ENGINE—5.4L—OIL SENDING UNIT INTERFERENCE FIT AT ENGINE OIL DRIP SHIELD—4X4 VEHICLES EQUIPPED WITH 5.4L ENGINE ONLY	Article No. 01-4-2

FORD: 1998 F-250 LD
1998-2001 EXPEDITION, F-150
1999-2001 SUPER DUTY F SERIES

Figure 1 - Article 01-4-2

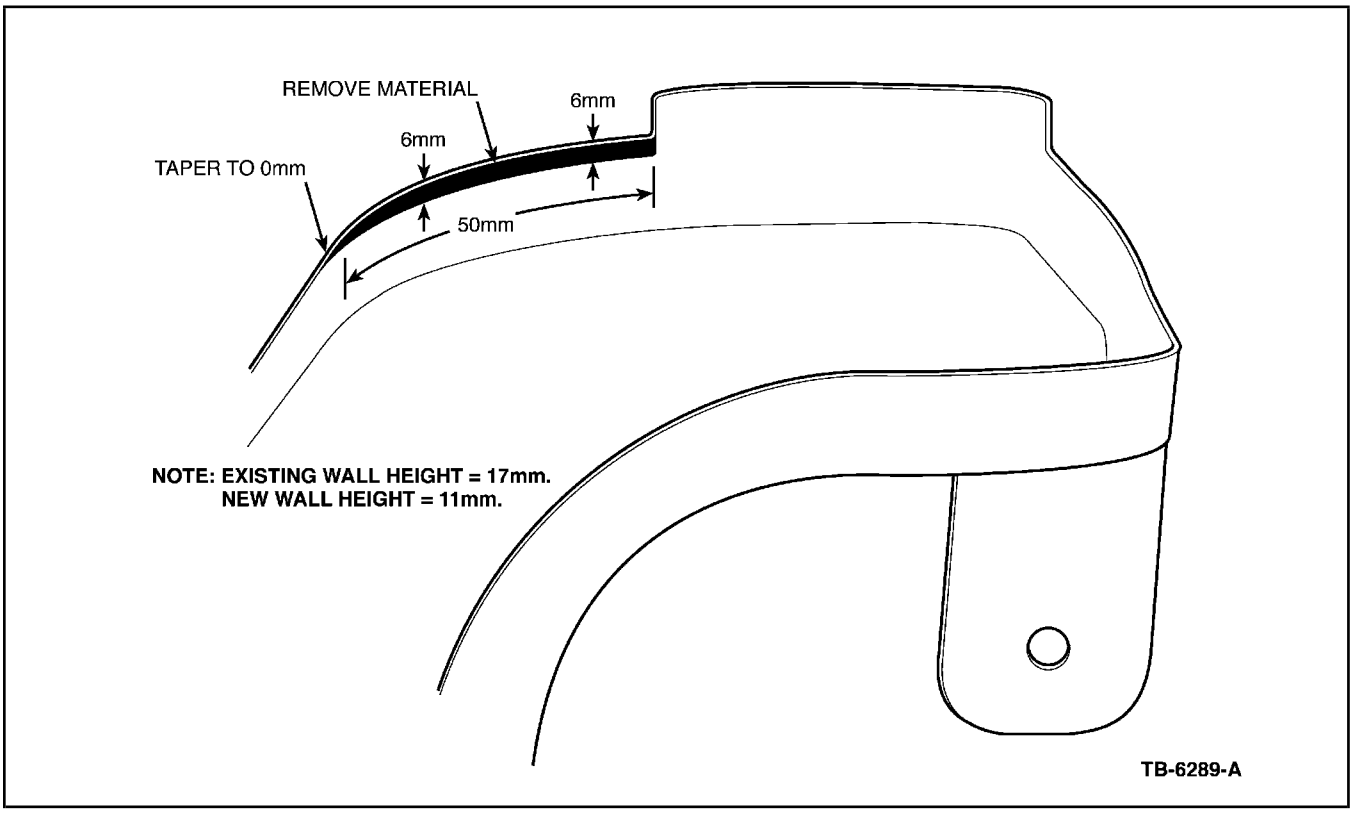
Some vehicles may exhibit the engine oil sending unit contacting the oil drip shield attached to the front axle. This may be caused by tight tolerances between the engine oil sending unit and the engine oil drip shield. This may cause a malfunction of the engine oil sending unit.

1. Remove oil drip shield from front axle. This shield is attached to the front axle by three (3) bolts.
2. Modify shield as shown (Figure 1). Remove excess material from shield. Remove any sharp edges or burrs upon finishing cutting operation.
3. Reinstall engine oil drip shield.
